**Re: ZC Case No. 20-06 / 1333 M Street, SE  
First-Stage PUD, Consolidated PUD, and Related Map Amendment  
Revised Section and Public Space Improvements Exhibit**

As a follow up to our most recent discussions regarding the above-referenced PUD application, attached please find (1) a revised Sheet A-2-4 for the Consolidated PUD Plans for Phase 1 of the PUD and (2) a public space improvements plan. These items are submitted in support of the Office of Planning's set down report to the Zoning Commission.

2 SECTION B-B  
SCALE: 1/60=1'-0"

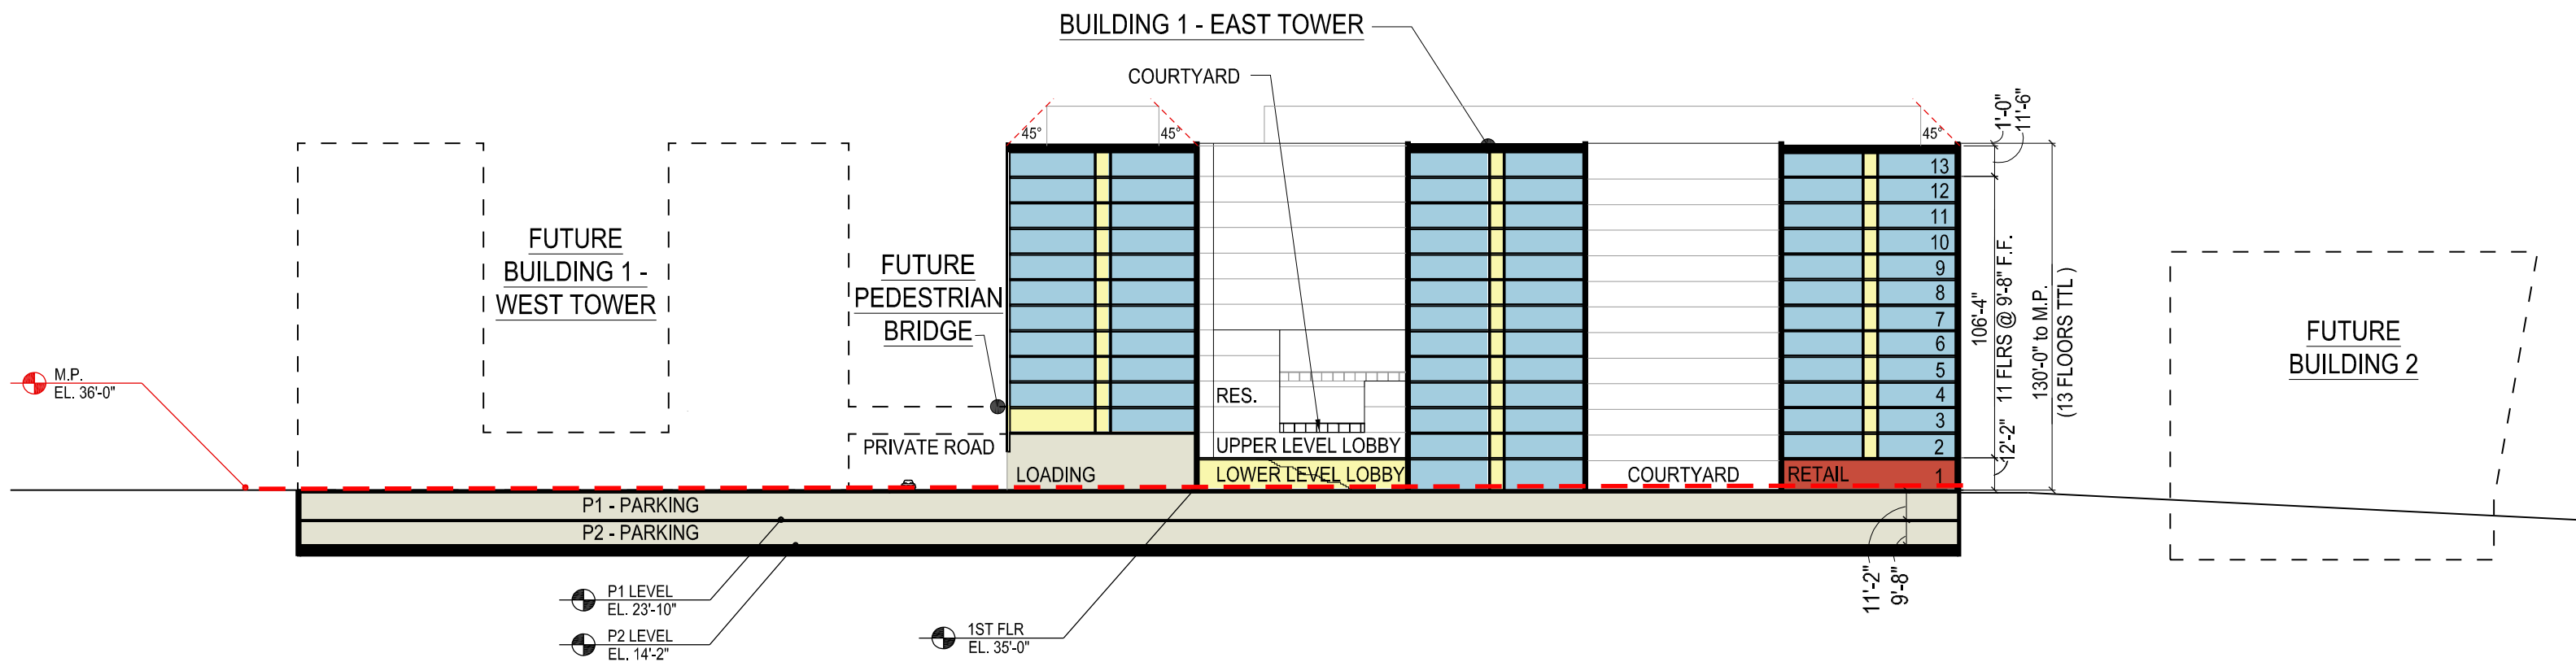
Sheet A-2-4 of the plans for the Consolidated PUD was revised to depict the parking structure below the East Tower and the West Tower, which will be constructed in Phase 1 of the project.
